69388/Full – Condition 11 Summary Document

LPA – Bury Council

RADHUB-VIN-XX-XX-RP-W-0301

Figure 2 - RADHUB-HES-V2-00-DR-E-6322 lighting layout for the terrace area.

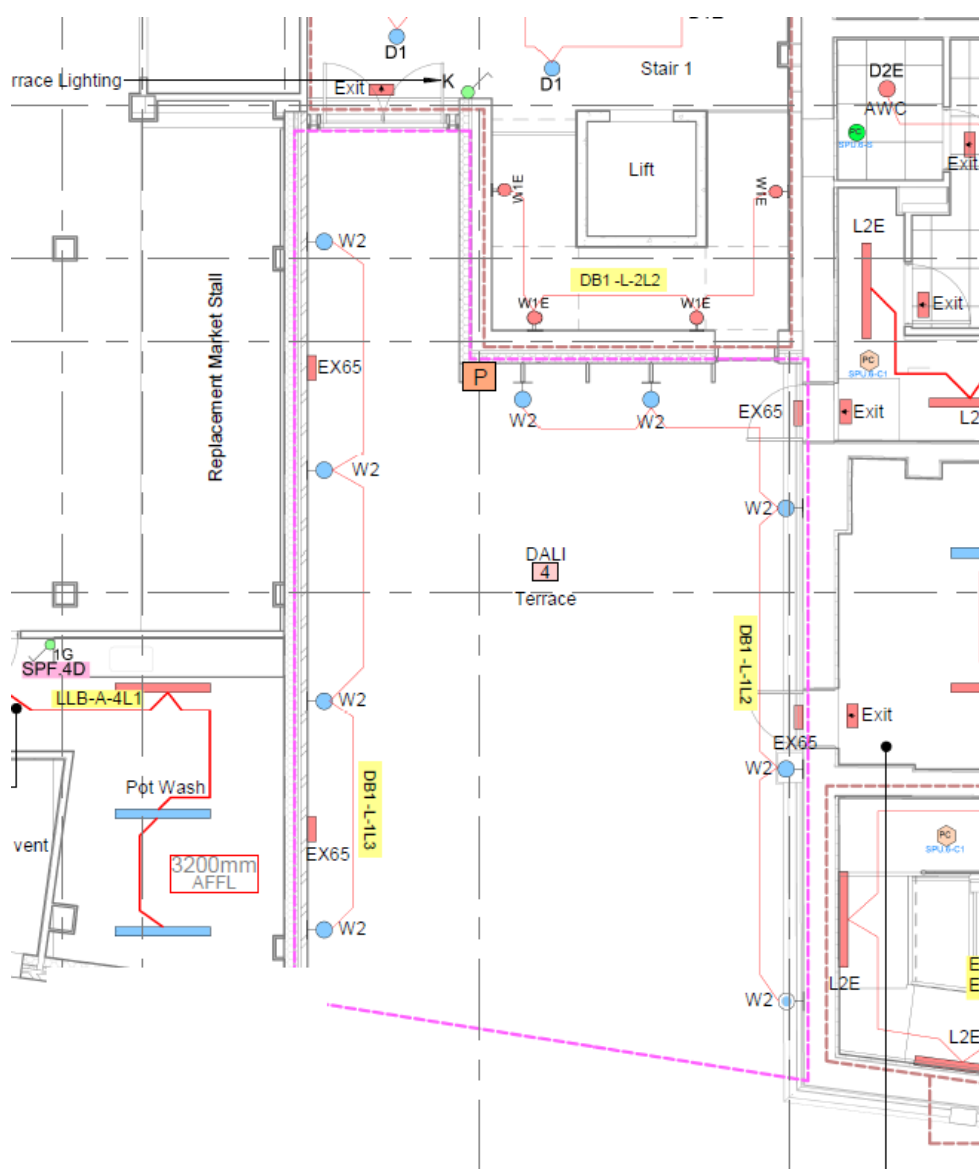
This layout, in addition to the lighting specification, has been provided to Vinci's consultant ecologist, RSK, who have undertaken a review. Please refer to the email correspondence entitled: *FW_ Radcliffe _ Condition 11 - External Lighting*.

In summary, RSK have confirmed that the "[lighting plan] ...*will minimize illumination of the river and help maintain it as a dark corridor for foraging bats.*"
